Courthouse Square

Re: Recommend approval of Change Order #20

CHANGE ORDER

CHANGE ORDER NUMBER: 20

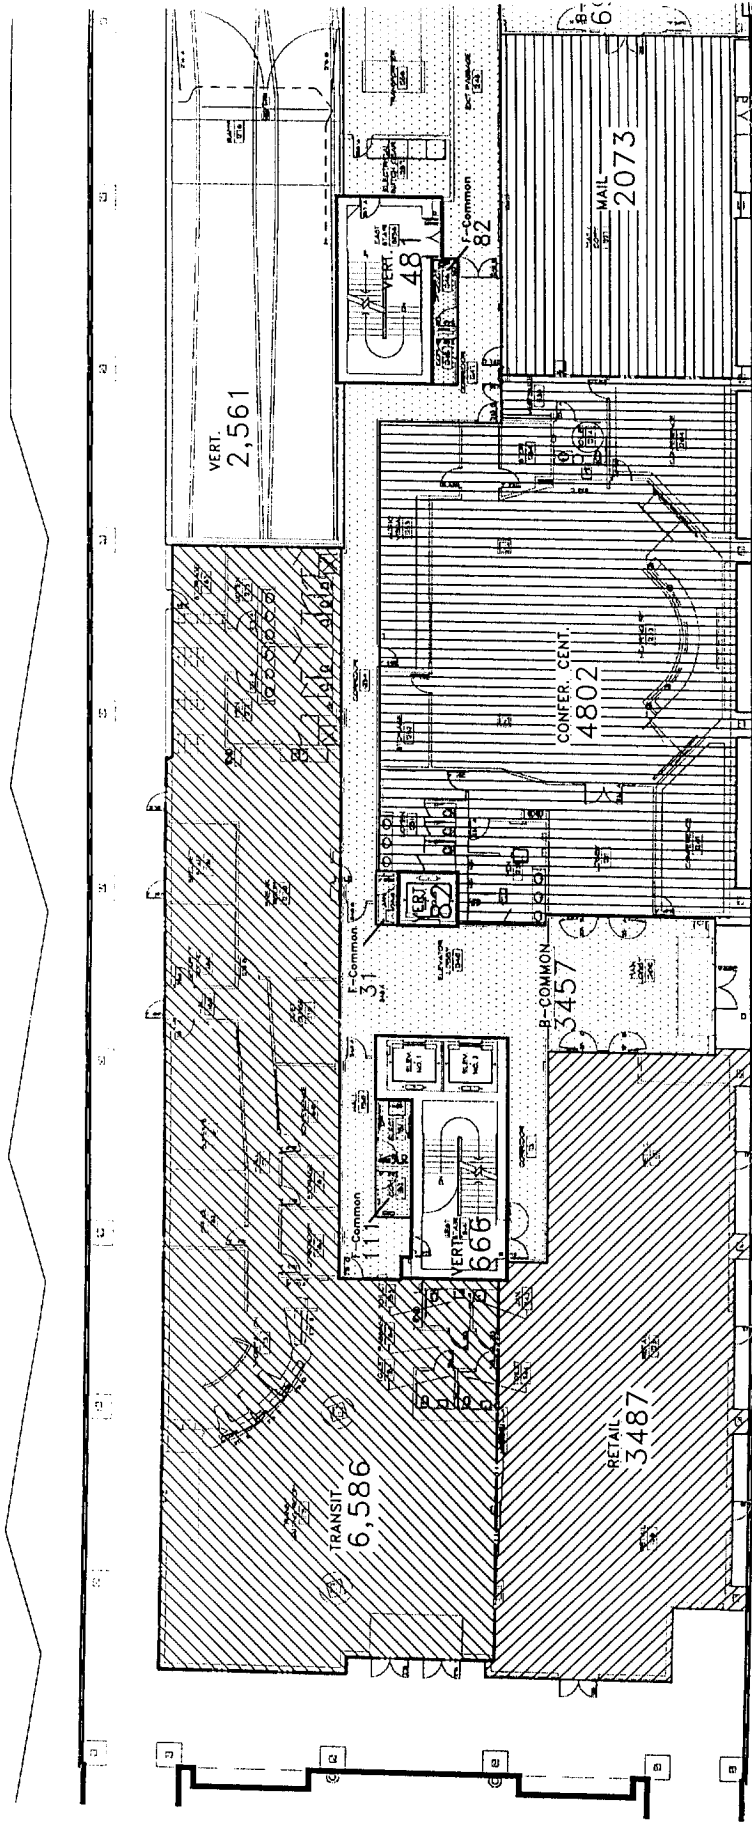
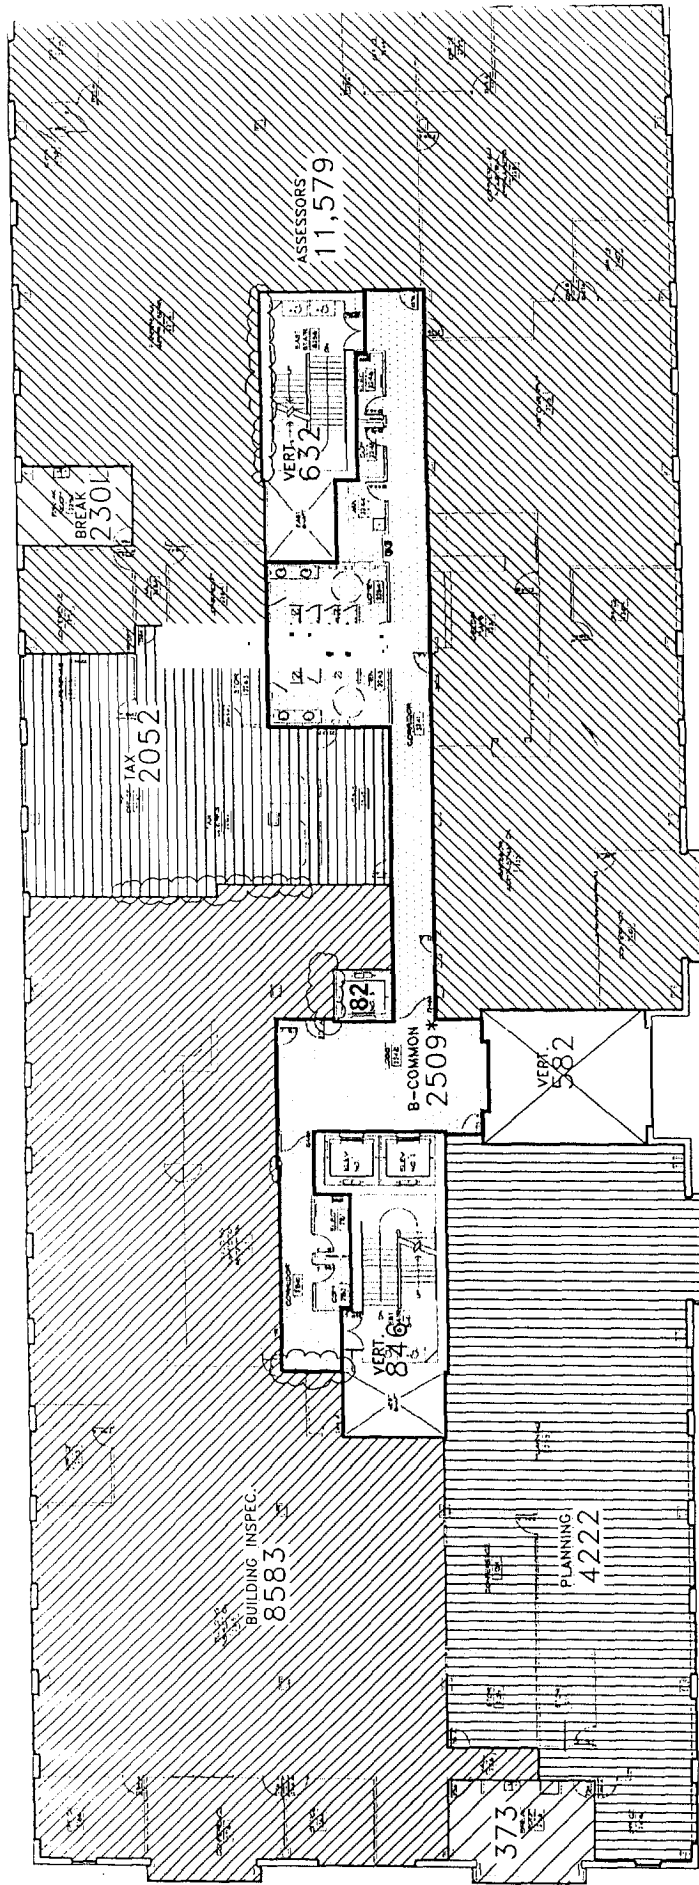
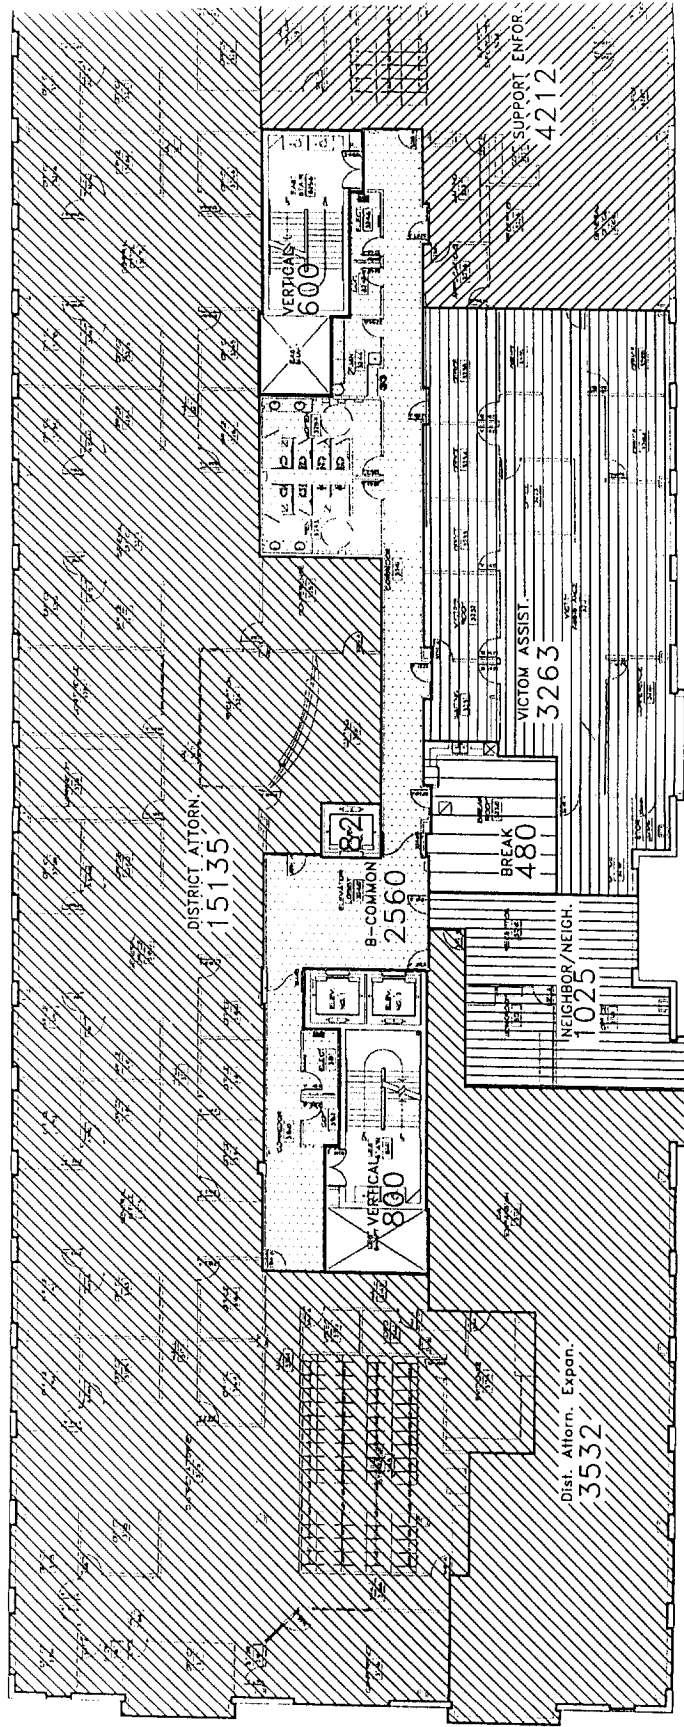
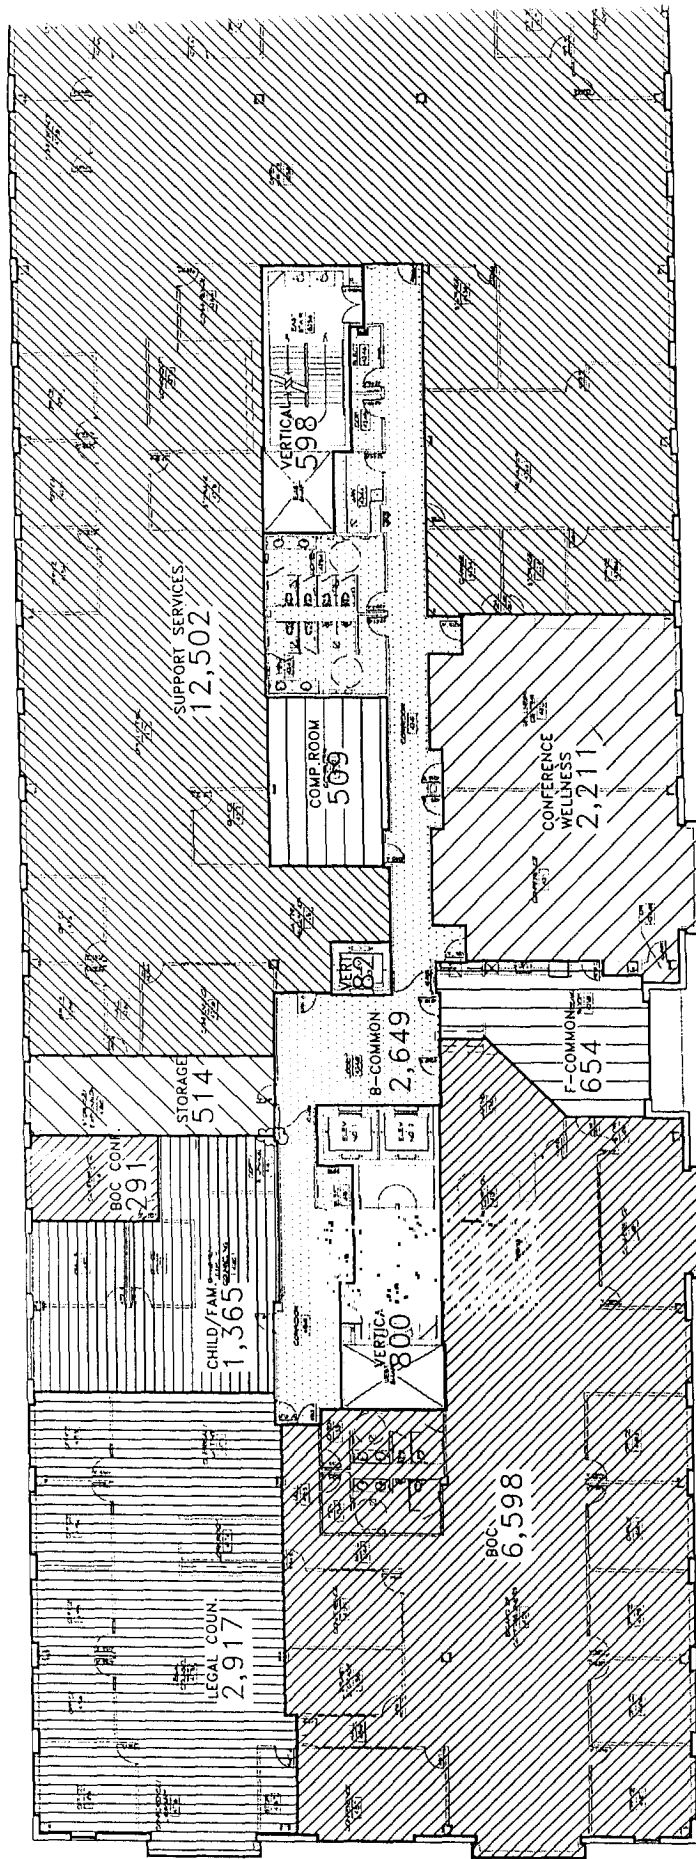
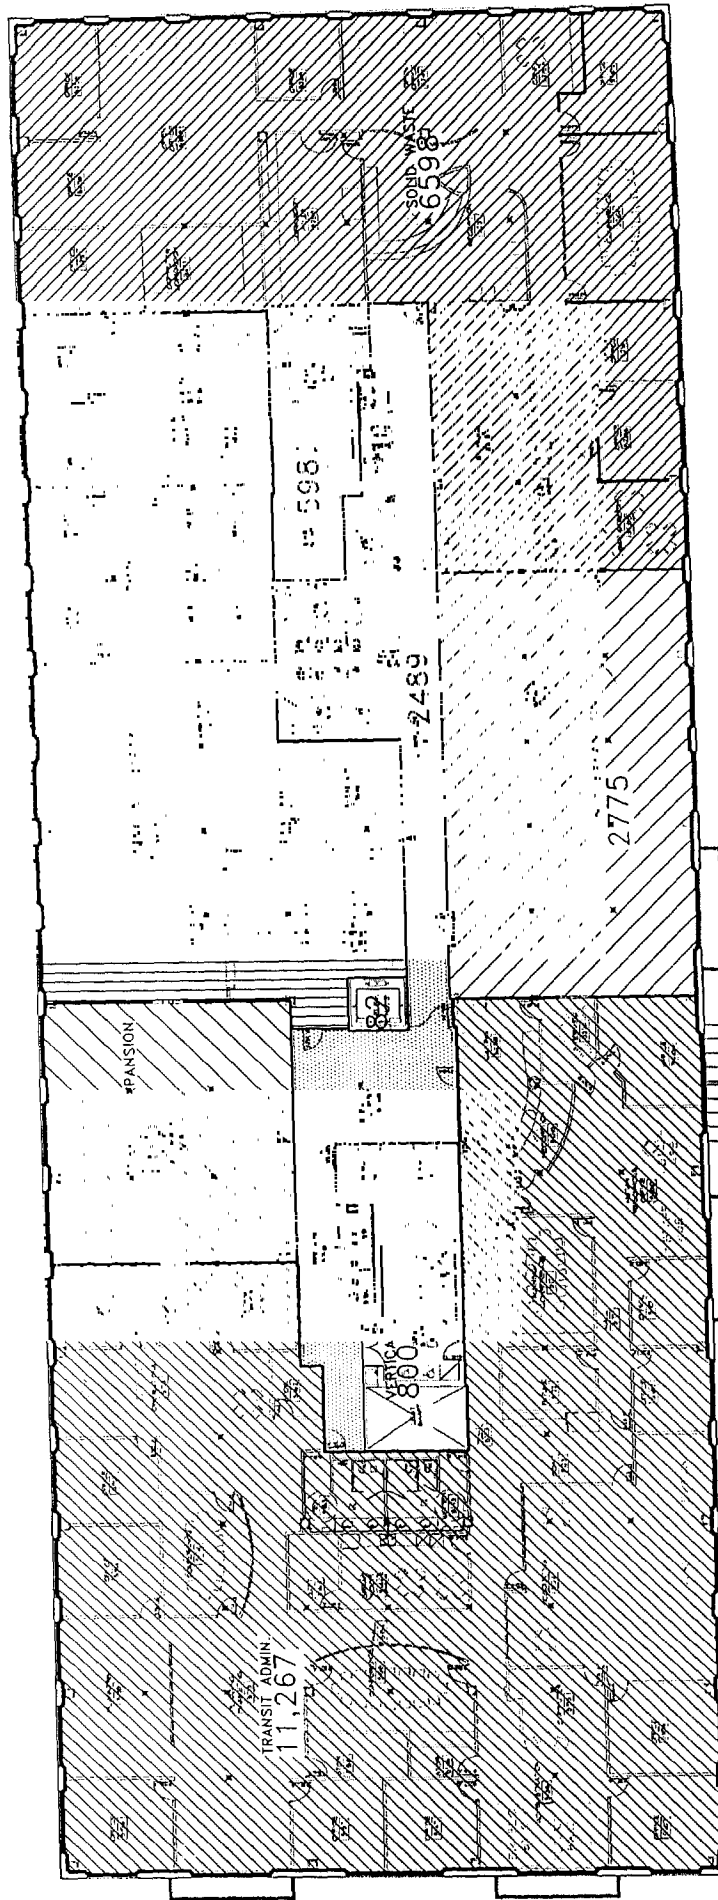
Provide Paging System per PR # 46. Price is based on 346 paging speakers, zoned in accordance with the layout furnished by Bob McCune dated 9/9/99.

PROJECT NAME CH²
PROJECT NO. _____
SUBJECT ROOF EL. BEAMS

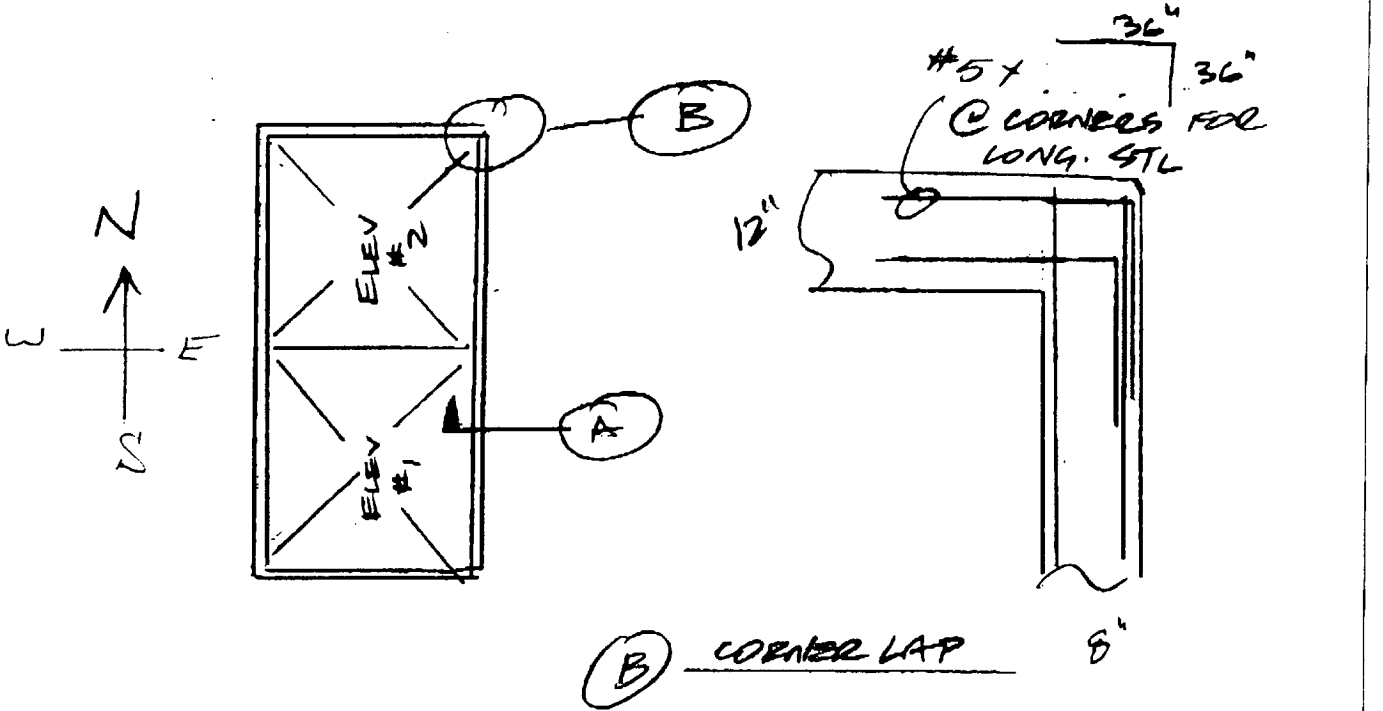
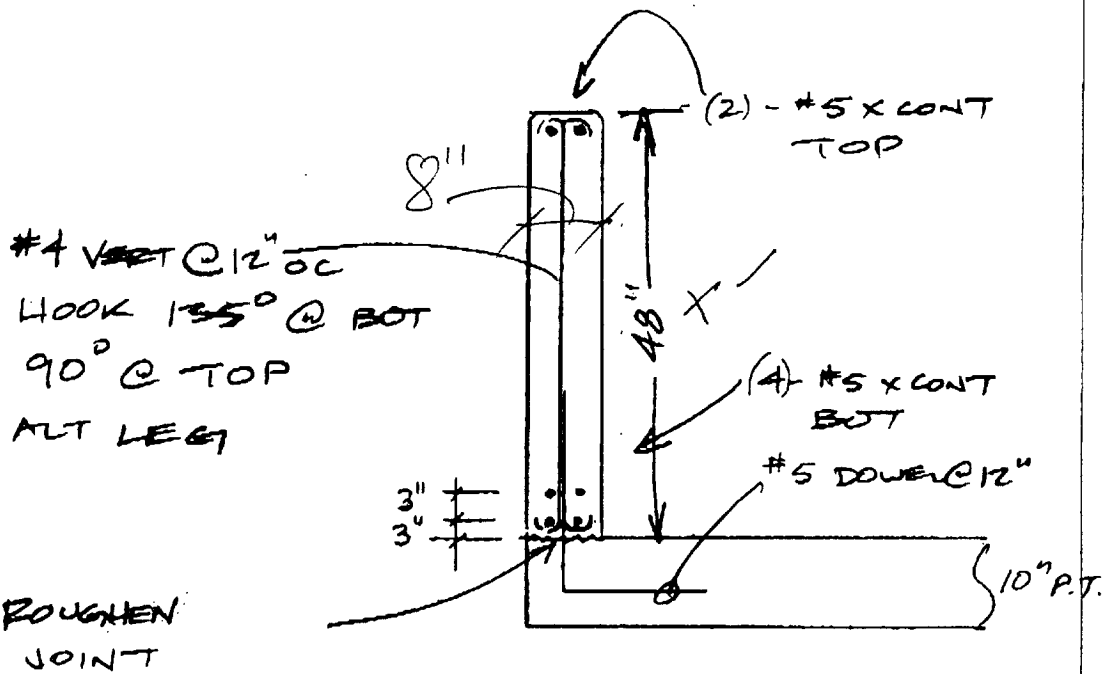
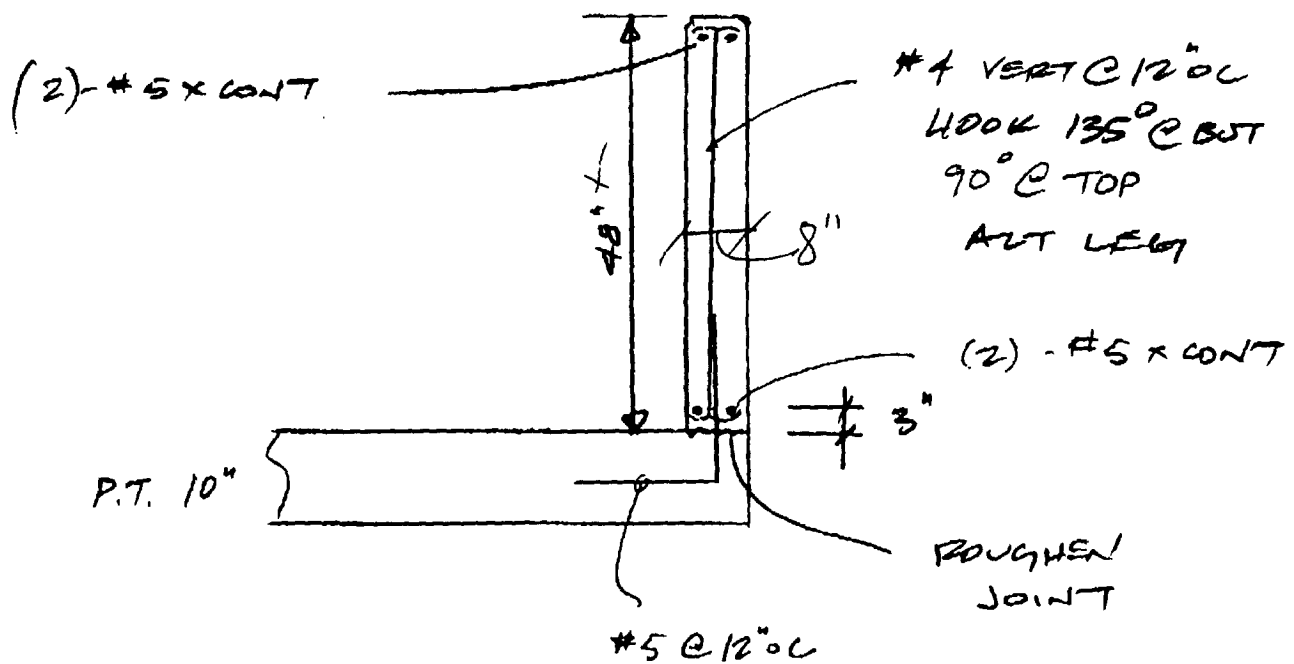
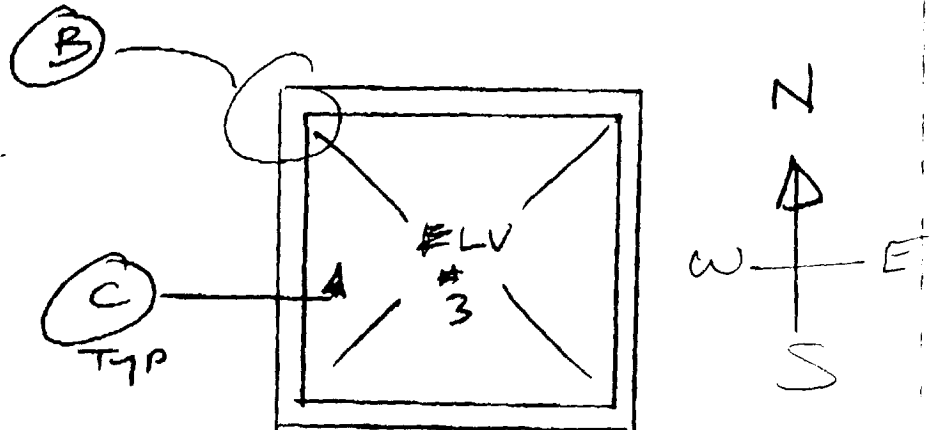
EXPLANATION OF CHANGE: PCC# 00089 ~~PR#71~~ *ISSUE 285*
Roof Walls at the Elevator have been revised per Century West sketches issued 12-8-99

Attached are sketches for additional reinforcing in the elevator beams/walls at the roof. The reinforcing is to transfer elevator beam reactions to support locations.
